# TRIDENT CASTER FLUTTER

### Trident Rear Wheel Flutter Solution

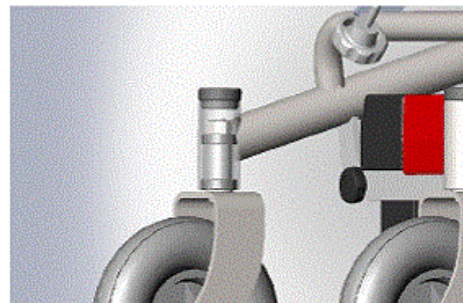
A recent improvement has been made to the Trident power wheelchair to eliminate the flutter in the rear caster wheels when travelling at full speed. The problem has been identified on a small sample of the Tridents, but if you are experiencing this problem, we offer the components (Part Number TRID-29) free of charge to eliminate this problem.

3. Using the washers supplied, install one washer per caster fork as pictured below (washer is highlighted in yellow)

4. Reinstall the two M12 nuts removed in Step 2, and replace the plastic caps removed in Step 1
